CHANGE ORDER NO. 3

PROJECT:	<u>Horizon City Municipal Facilities Phase I</u>	DATE OF ISSUANCE: March 10, 2025
OWNER:	TOWN OF HORIZON CITY 14999 Darrington Rd. Horizon City, Texas 79928	EFFECTIVE DATE: March 11, 2025
CONTRACTOR:	<u>Dantex General Contractors</u> <u>4727 Osborne</u> El Paso, TX 79922	OWNER'S BID NO. CSP 23-038 Project No. 22.513D
CONTRACT FOR:	<i>New Municipal Facilities for the City of Horizon</i>	ARCHITECT: Eugenio Mesta, AIA Exigo Architects 211 N. Florence Ste. A El Paso, Tx 79912

YOU ARE DIRECTED TO MAKE THE FOLLOWING CHANGE TO THE CONTRACT DOCUMENTS:Item No. 1: **Additional Concrete at Metal Building Area B** - (\$22,691.25; 0 impact to contract time)**PURPOSE OF CHANGE ORDER:**

TITLE: Additional Concrete Work

ANCHOR BOLT PLAN
F.F. ELEV. 100'-0"
ALL B.P.E. 100'-1 1/2" ON
OF NON-SHRINK GROUT U.N.O.

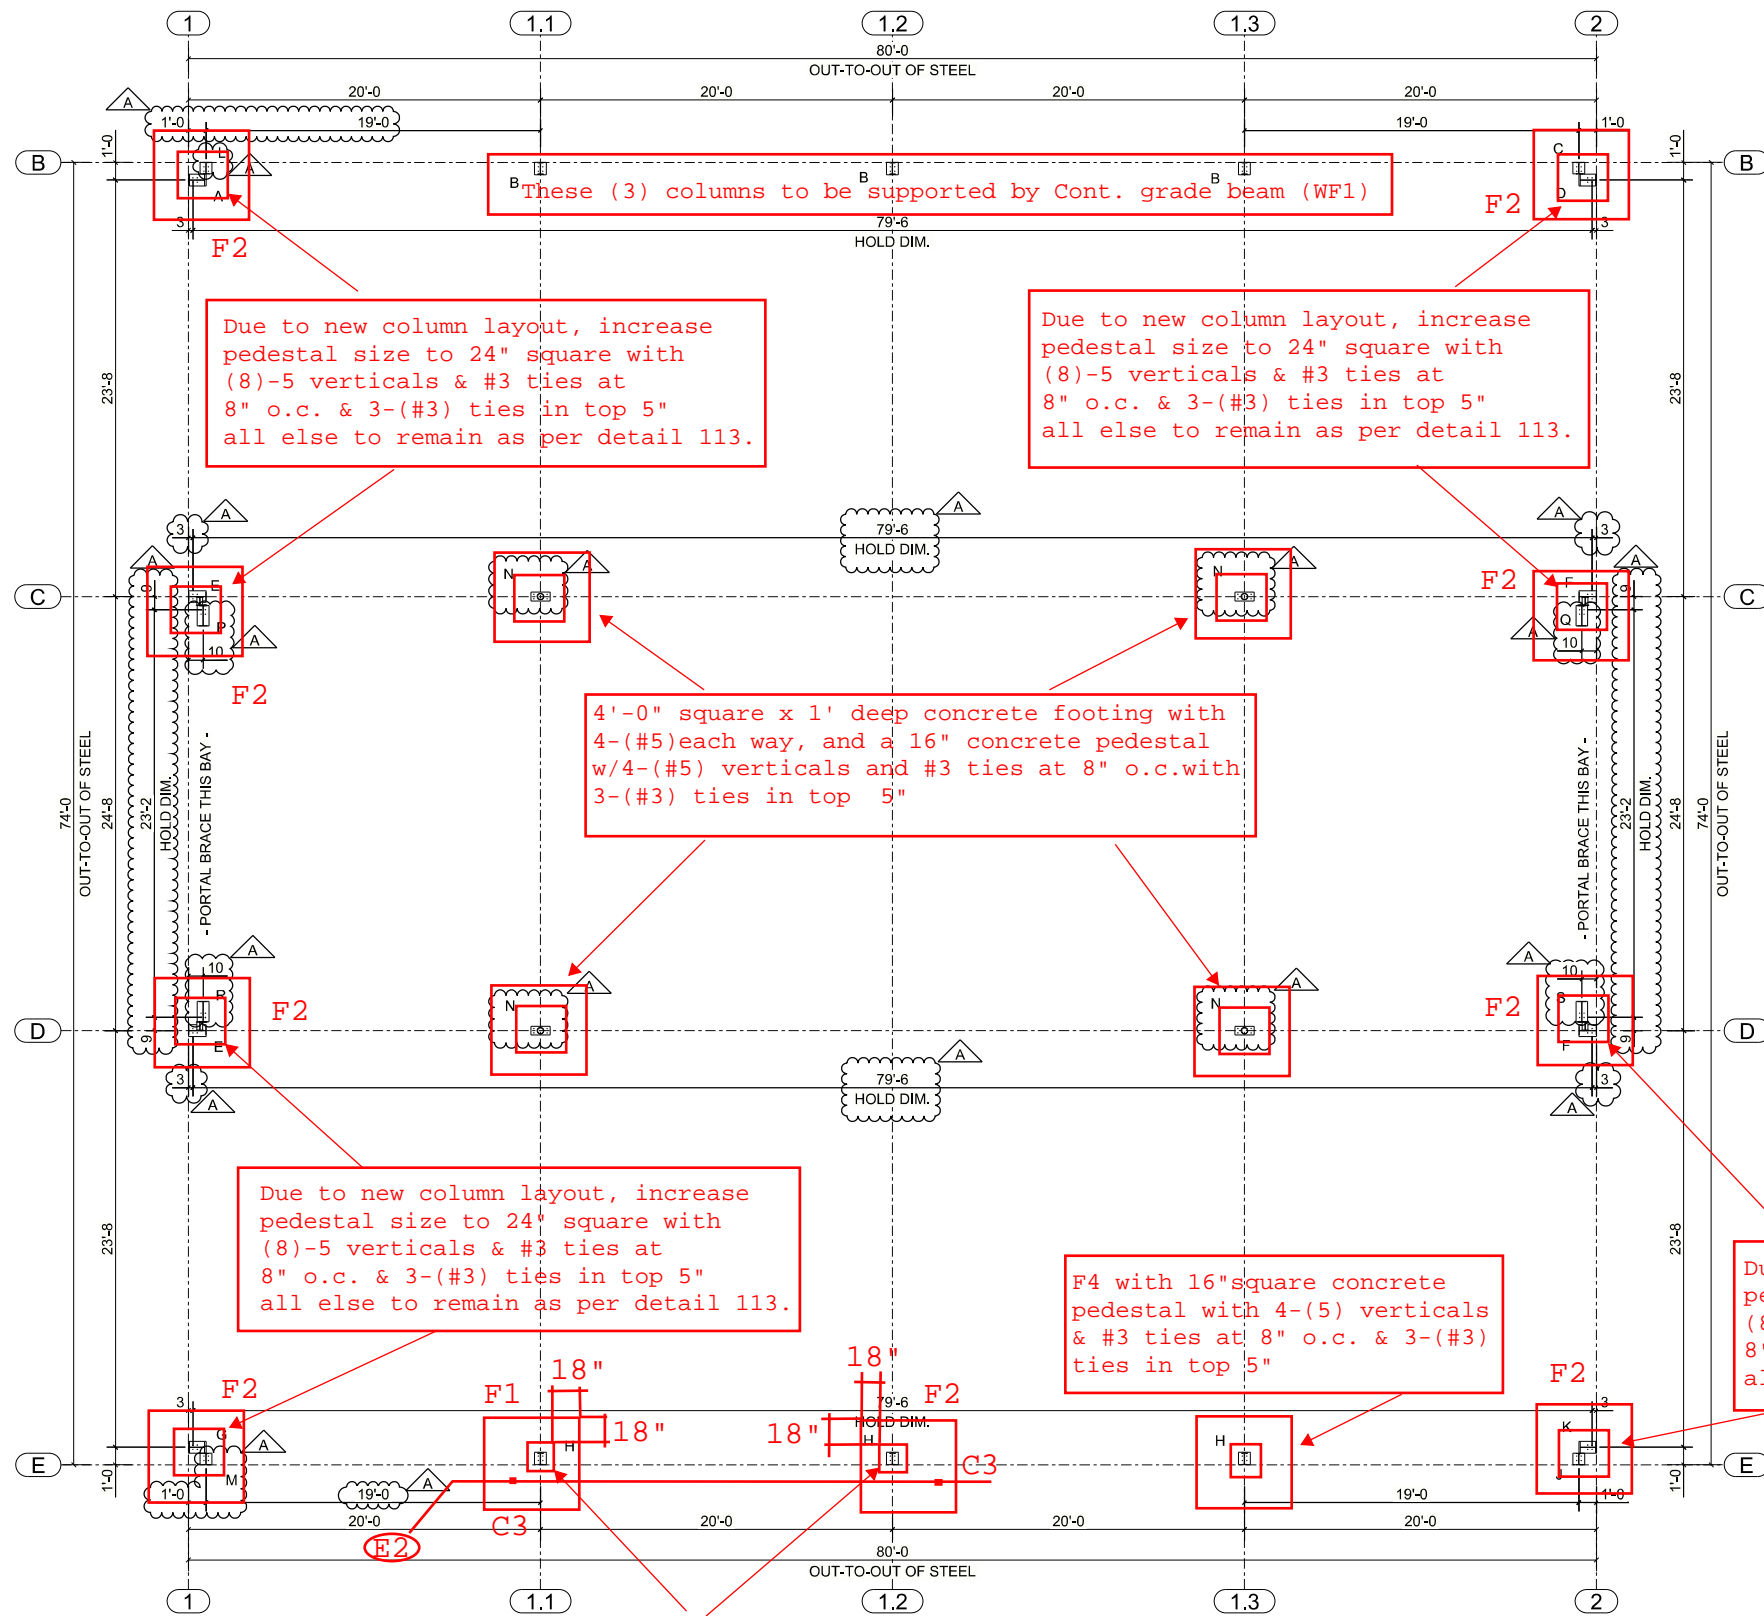
Due to new column layout, increase pedestal size to 24" square with (8)-5 verticals & #3 ties at 8" o.c. & 3-(#3) ties in top 5" all else to remain as per detail 113.

Due to new column layout, increase pedestal size to 24" square with (8)-5 verticals & #3 ties at 8" o.c. & 3-(#3) ties in top 5" all else to remain as per detail 113.

4'-0" square x 1' deep concrete footing with 4-(#5) each way, and a 16" concrete pedestal w/4-(#5) verticals and #3 ties at 8" o.c. with 3-(#3) ties in top 5"

Due to new column layout, increase pedestal size to 24" square with (8)-5 verticals & #3 ties at 8" o.c. & 3-(#3) ties in top 5" all else to remain as per detail 113.

F4 with 16" square concrete pedestal with 4-(5) verticals & #3 ties at 8" o.c. & 3-(#3) ties in top 5"

Due to new column layout, increase pedestal size to 24" square with (8)-5 verticals & #3 ties at 8" o.c. & 3-(#3) ties in top 5" all else to remain as per detail 113.

16" square concrete pedestal with 4-(#5) verticals & #3 ties at 8" o.c. & 3-(#3) ties in top 5"

G.C. To coordinate column locations with architectural drawings. Footings/pilasters have been provided.
JTA Engineering
